ADDENDUM NO. 1
March 4, 2022

DLH Runway 3-21 Lighting and Signage Replacement
City of Duluth No. 21-4401
AIP No. 3-27-0024-072-2022
Duluth International Airport (DLH)
Duluth Airport Authority

SEH No. DULAI 164242

ELECTRICAL NEW WORK
PLAN 5

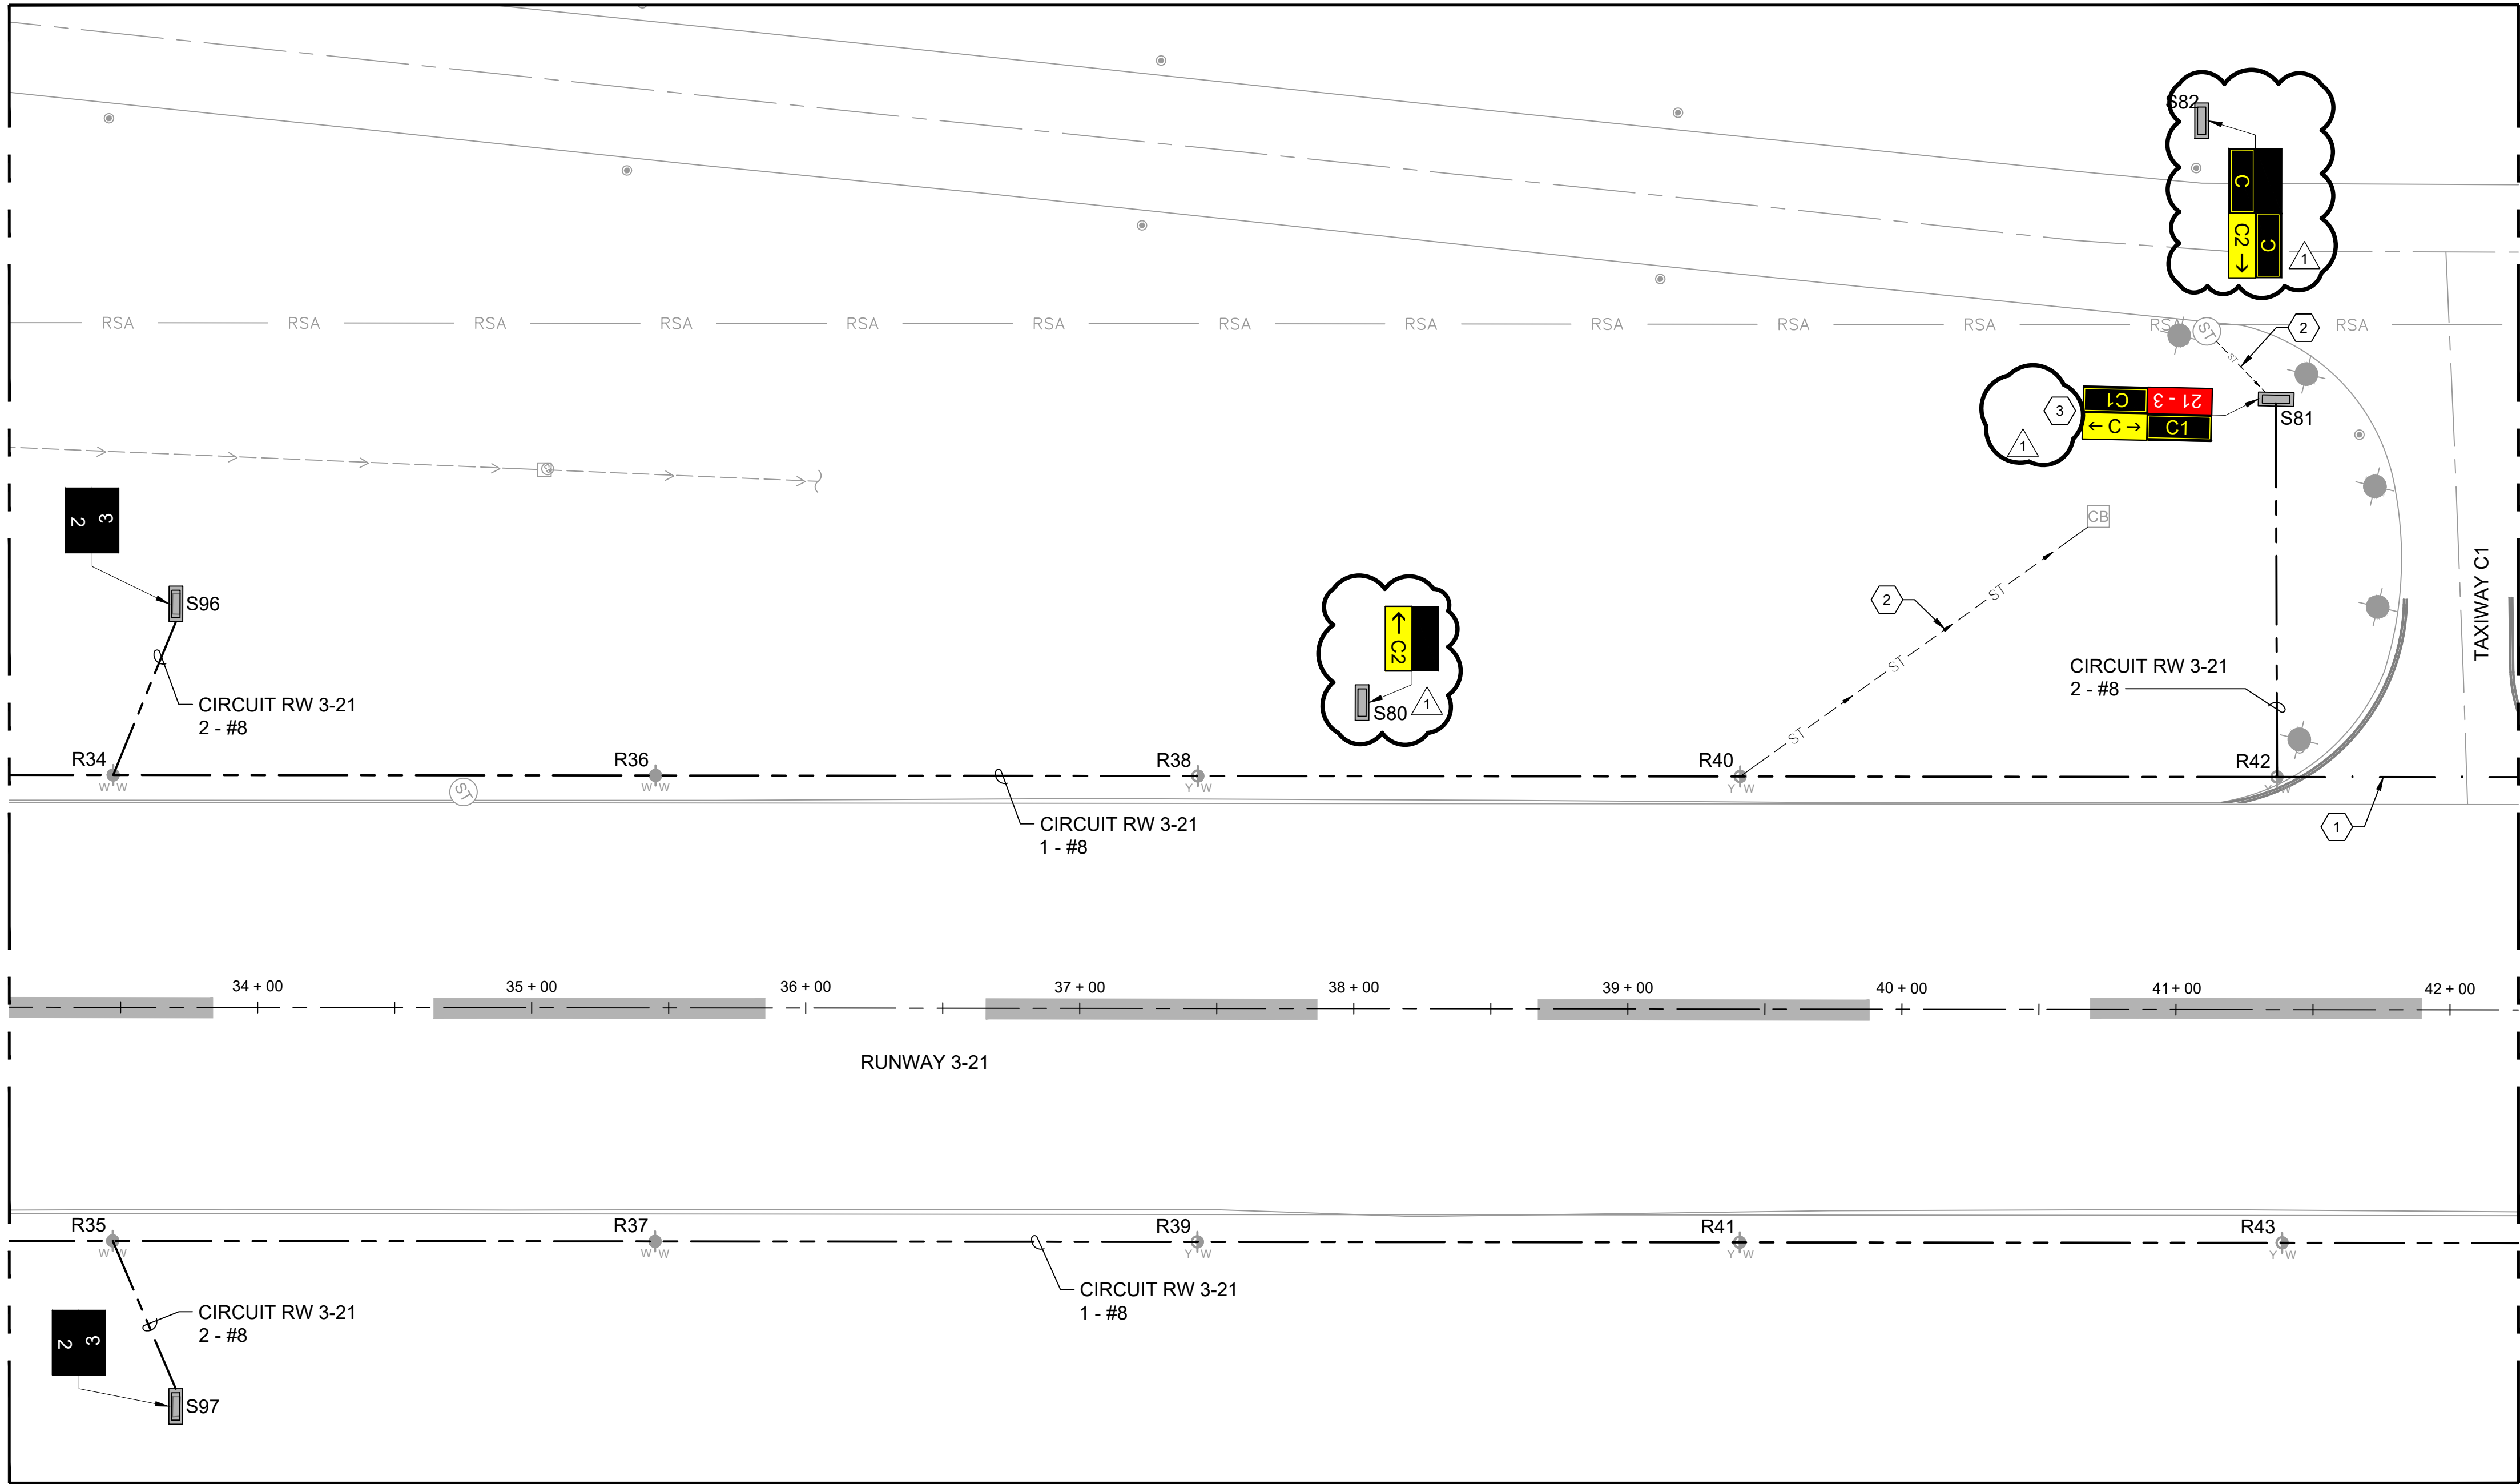
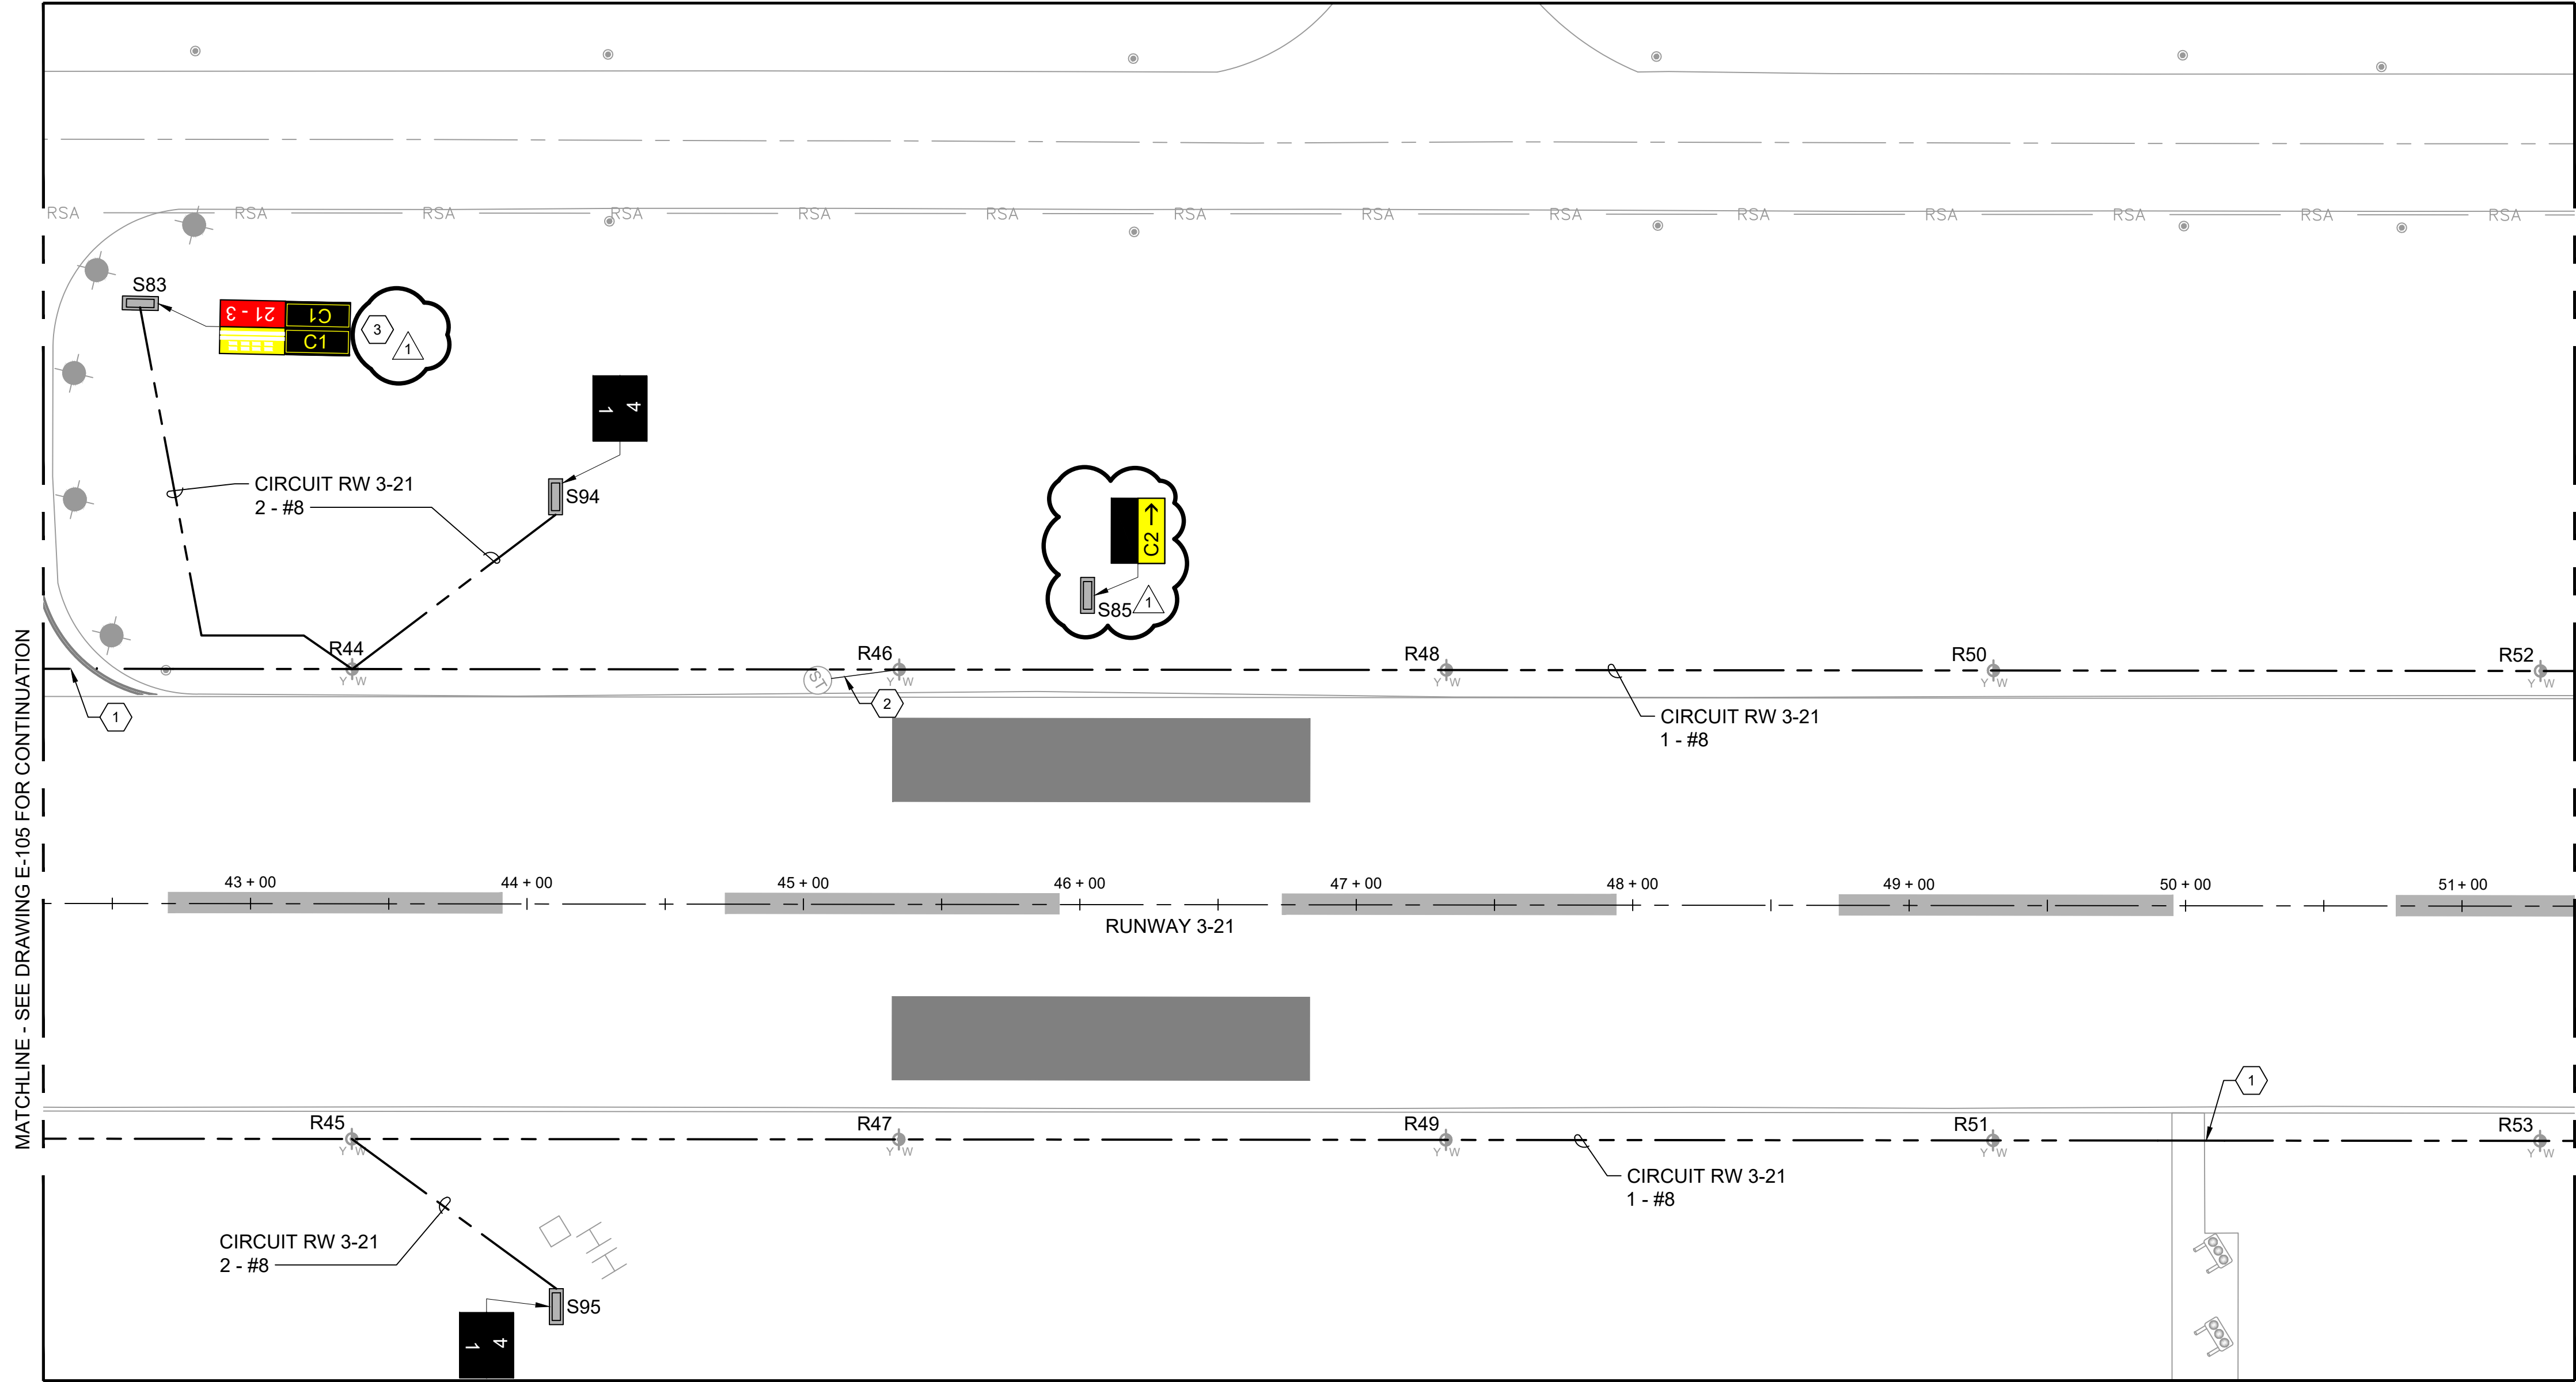
11. Drawing E-105 Electrical New Work Plan 5 – Bid Alternate Sign Schedule Added. Signs affected by alternate bid sign schedule are identified in the Electrical New Work Plan and notes have been updated.

SHEET
E-106

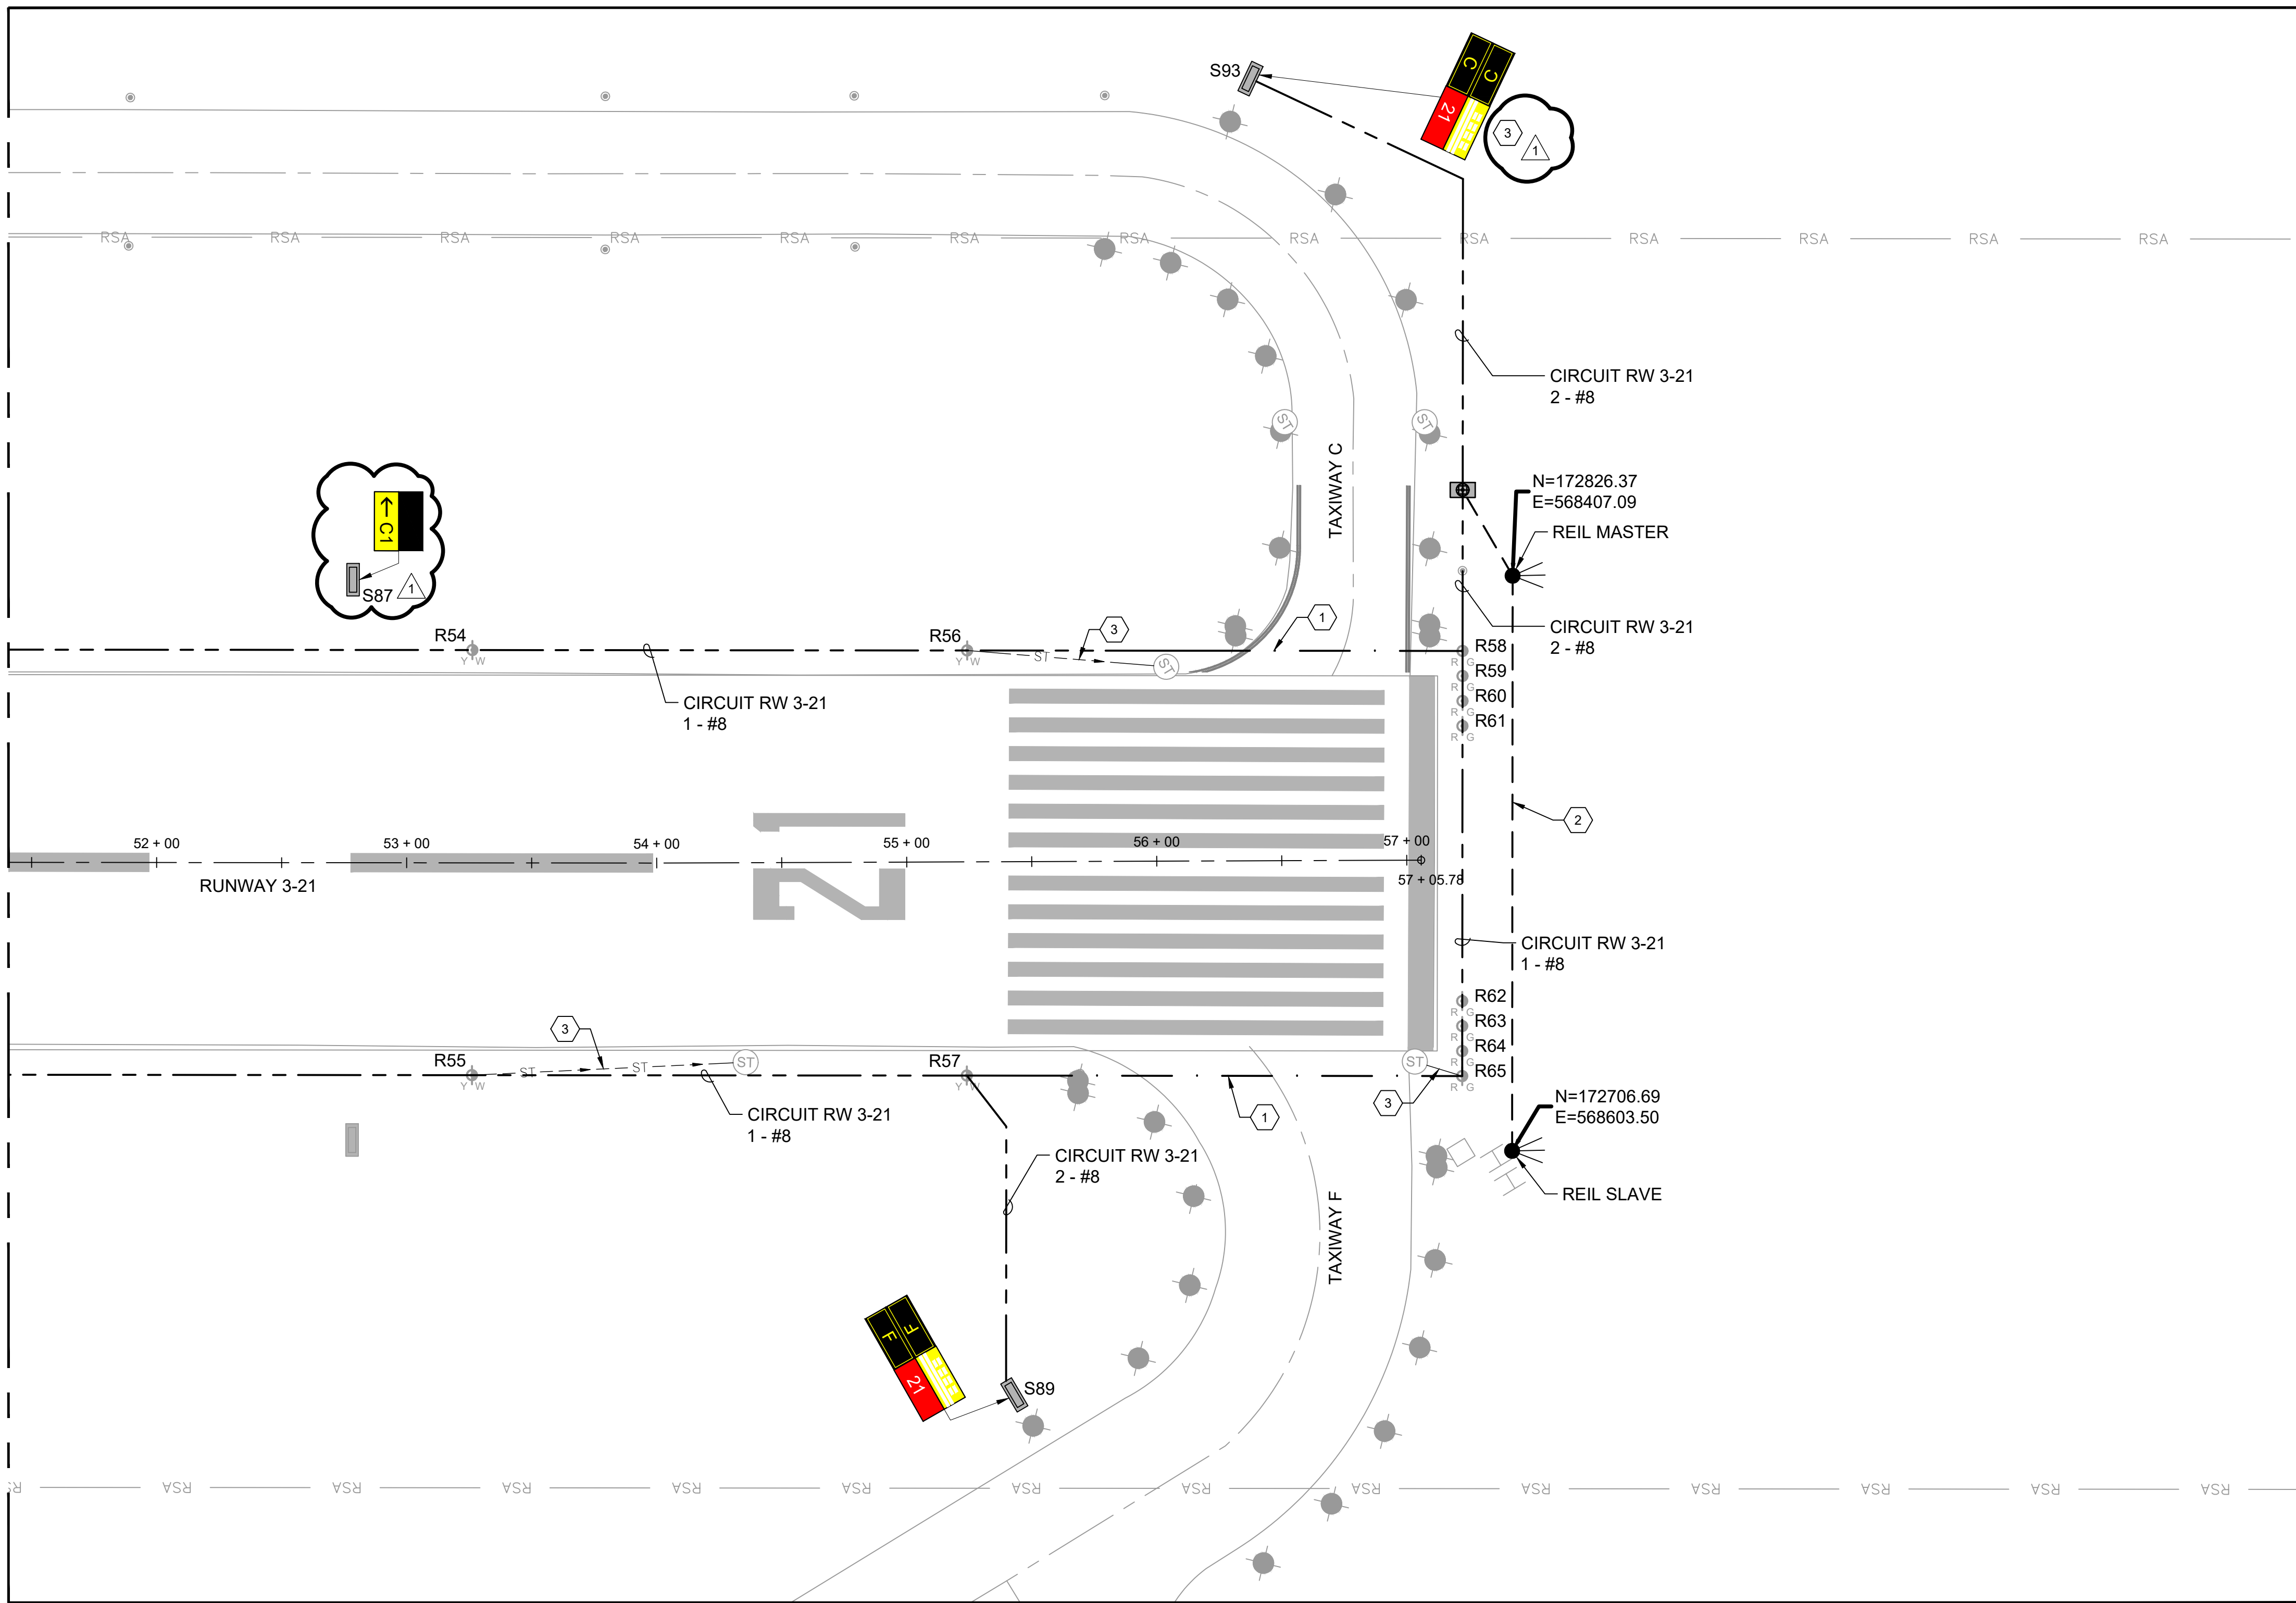
12. Drawing E-106 Electrical New Work Plan 6 – Bid Alternate Sign Schedule Added. Signs affected by alternate bid sign schedule are identified in the Electrical New Work Plan and notes have been updated.
